United Nations Development Programme UNDP- Sudan	 <i>Empowered lives. Resilient nations.</i>	<div style="background-color: black; color: white; padding: 5px; text-align: center;">PRE-BID CONFERENCE MINUTES</div> <div> ITB Number: ITB/KRT/GF/17/013 Page 1 of 2 MEETING DATE: 09 April 2017 MEETING LOCATION: KHARTOUM MEETING TIME: 12:30 pm to 13:30pm </div>
---	--	---

The purpose of this meeting is to clarify issues and to answer questions on any matter that may be raised in respect to the ITB No. ITB/KRT/GF/17/013 for Construction/Rehabilitation Works of ART Center in Tropical Diseases Teaching Hospital

**ART CENTER BUILDING
OMDURMAN TROPICAL DISEASES HOSPITAL
BILL OF QUANTITIES**

R.C. Strip Found. Sec.

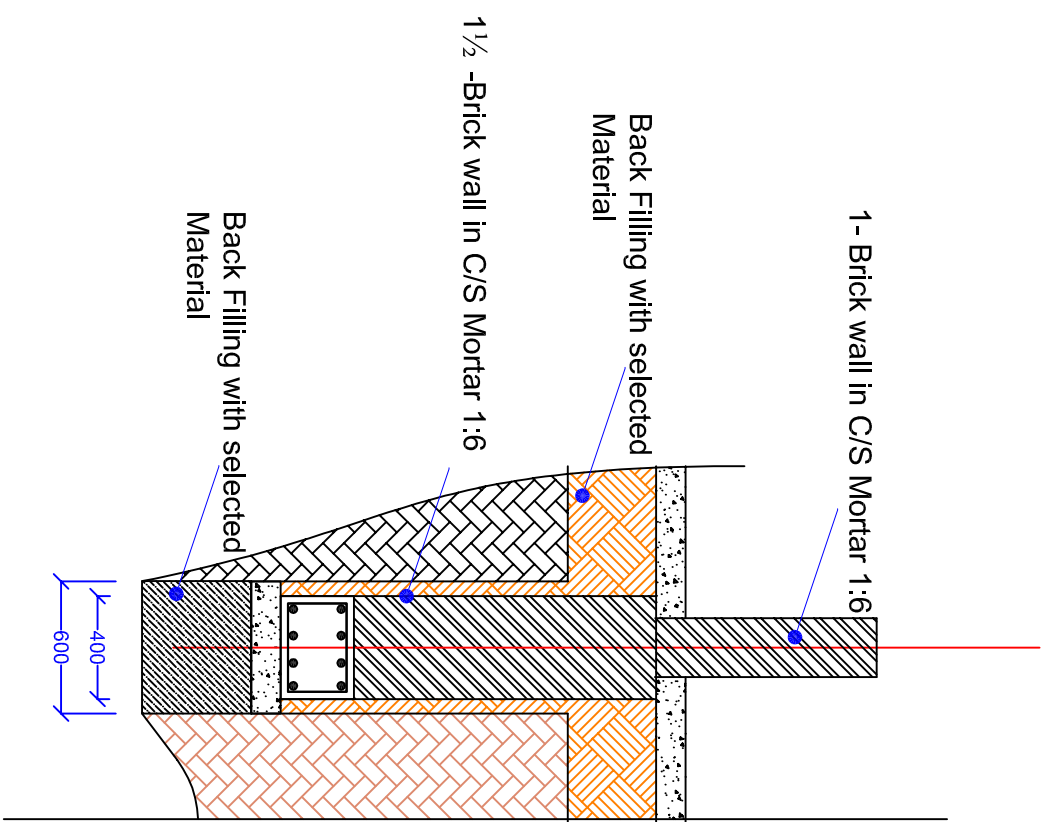
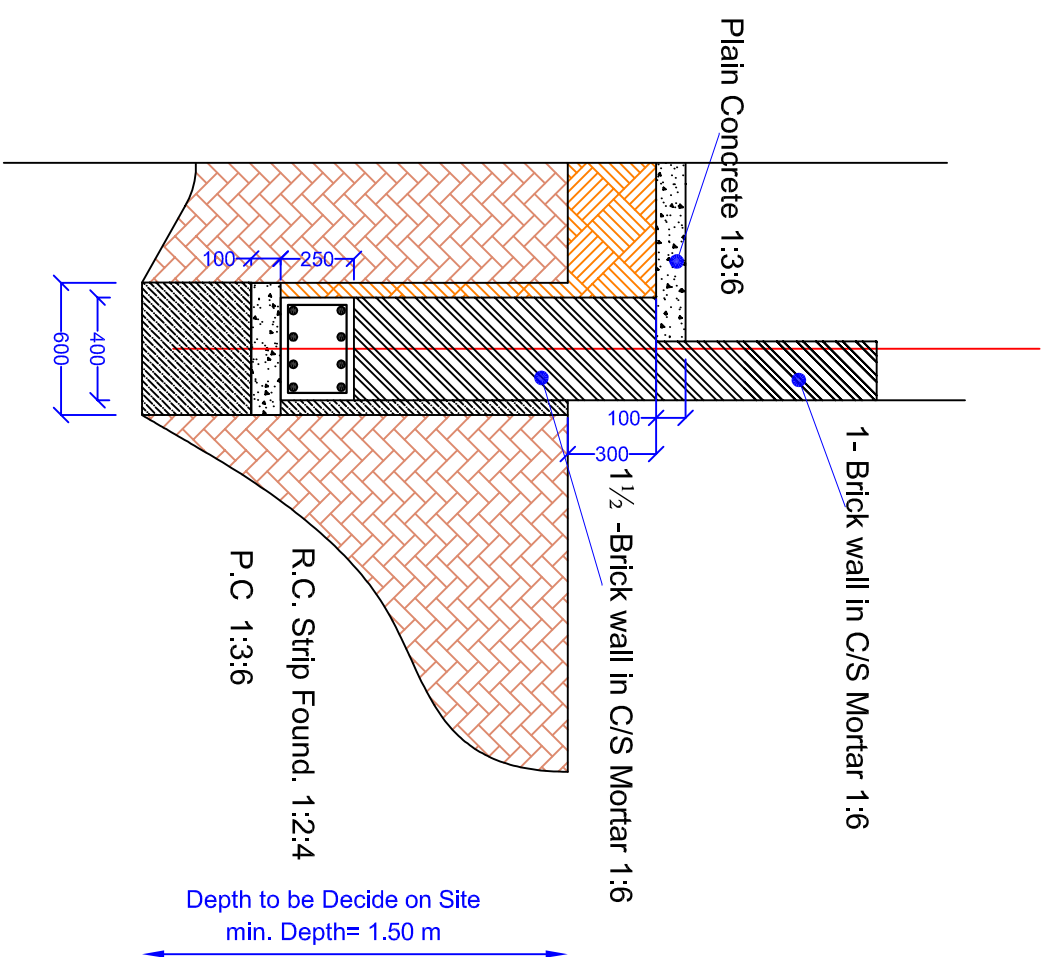
Q4	Inspection Form	Is it mandatory to submit the site inspection form?
Response Q4		Yes, it is mandatory to submit signed and stamped site inspection form.
Q5	Strip Foundation	What is the structure details for the Strip Foundation?

Response Q5		Please refer to annex II for the structure details for the Strip Foundation.
Q6	Bill No. (1): Preliminaries	Under Preliminaries (bill no.1), Is it possible to provide a prefabricated office in the site?
